Interactive comment on “Caffeine vs Carbamazepine as indicators for wastewater pollution in a karst aquifer” by Noam Zach Dvory et al.

Answers to Reviewer #2 comments:

Fig. 1. The upper Sorek Basin monitoring sites and flow and transport simulation domains (after Dvory et al., 2018a; aquifer boundaries from Dafny, 2009)

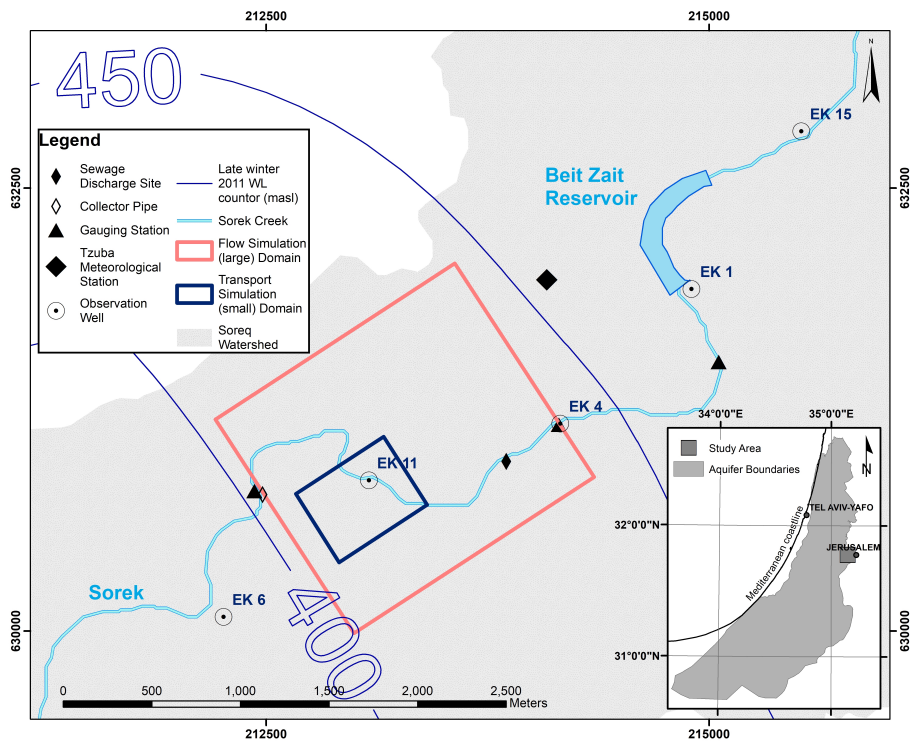
Figures 1,2 and 3b are taken from the previous manuscript with no or very little modification. In addition to the overlap as indicated by the editor this should be fixed (Figure 1 is probably the most critical one and should be slightly modified, also to

Answer: As suggested by the reviewer, the Fig. 1 was modified. In the caption under figure 2 (Figure 3 in the revised manuscript) we indicate that the figure references Dvory et al., 2018a. Figure 3 (Figure 4 in the revised manuscript) includes CAF concentration unlike the previous paper published in WR.

Fig. 2. Model conceptual sketch

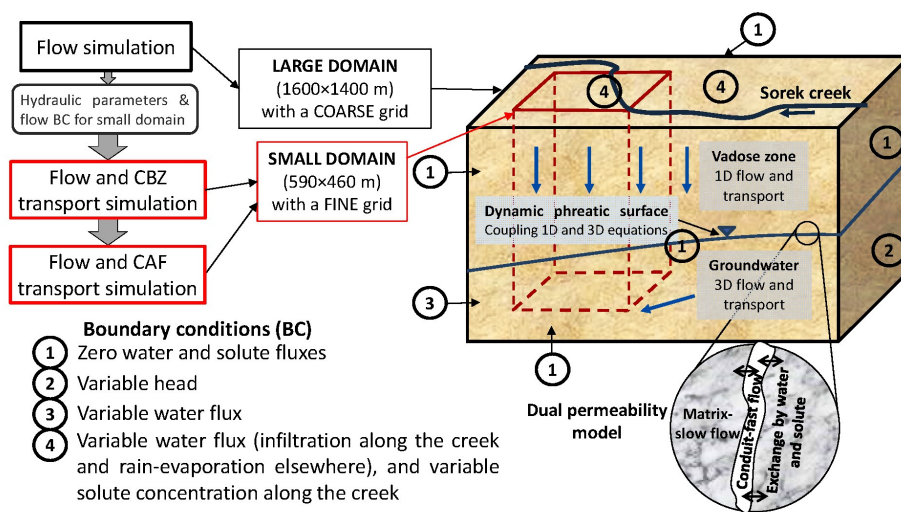
2. (p5): The section "Numerical model" would greatly benefit from a conceptual sketch of the model framework (the Water Research paper provides a conceptual model of the hydrogeological system only). The model is quite complex and as the authors have already limited the model description here. A conceptual sketch would also allow readers to understand more aspects of the model without first having to read another paper. This would also help to make the paper stand out slightly more compared to the WR paper.

3. (p5, line 28): From the description here it is not entirely clear to me if both the 1D and 3D part of the domain are subject to a multi-continuum coupling. In this sense also the terms high and low permeable region are (from a conceptual point of view) associated with different compartments of the aquifer. High permeable regions in the vadose zone are possibly (enlarged) fractures and to a limited degree former conduit systems depending on the long term evolution of the system, while in the 3D part the high permeable regions are commonly the conduits. This should be clarified, possibly also in conjunction with my previous comment to add a conceptual sketch.

4. (p6): In addition to the conceptual sketch I think a figure showing the discretized model domain including boundary conditions (both for the large and small model) would be adequate to be added to the section "Mathematical model setup".

Answer: As suggested by the reviewer, we added an additional figure (fig. 2) that we hope that will assist the readers to understand the model framework.

Answer: In the revised manuscript we clarify that multi-continuum coupling was done for both the unsaturated and saturated zones, which is also shown in the conceptual sketch (new Figure 2). In the mathematical model, fractures and conduits belongs to one continuum, while porous matrix to another.

Answer: We present the boundary conditions in Figure 2 (according to the revised version), however we prefer not to show the finite-differences discretization of the domains because it's technical and overloads the figure. The sizes of numerical grids are mentioned in the text.

Fig. 5. Simulated CAF sensitivity to parameters changes (A) the degradation rate and (B) the distribution coefficient. The insets show the effect of parameters on RMSE.

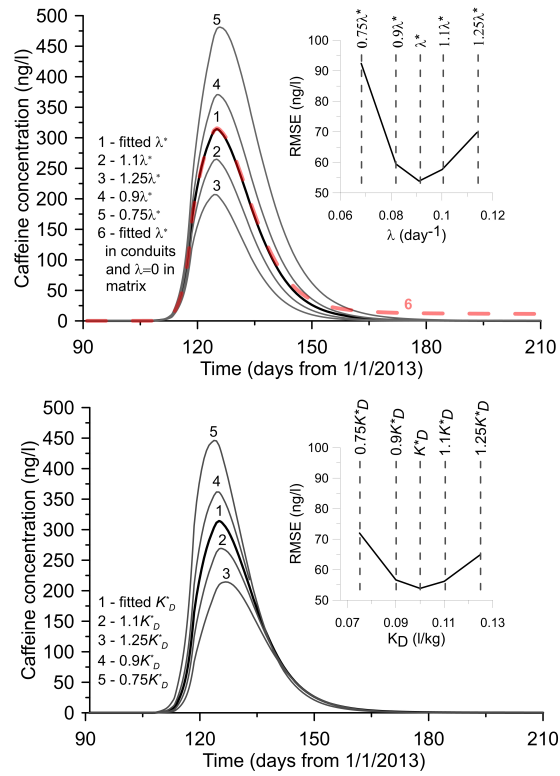
7. (p13, Fig4): I am a bit confused by both sensitivity analyses but may have missed some information in the manuscript. I would expect an opposite behavior for λ as well as K_d . I would expect lower peaks (and low tailing, i.e. generally a decline in mass) for higher values of degradation. The same applies for the distribution coefficient (which to my knowledge is commonly defined as activity of solid/aqueous phase). Here I would expect lower peaks for higher values of K_d as CAF tends to be in a sorbed state. In Figure 4a it is difficult to see where the peak of parameter combination 6 is (only the tailing is clearly visible). A different color (gray or colored) for the fitted values (both in A/B) could help to enhance visual clarity.

6. (p13, Fig. 4): Please match the font/fontsize of the insets in A and B (λ and K_d values)

Answer: Thank you for this important remark. The legend in this figure was wrong. We corrected the legend and the text accordingly. We also changed this figure (Figure 5 in the revised manuscript) to make it more coherent by distinguishing between the

Answer: The correction has been made.
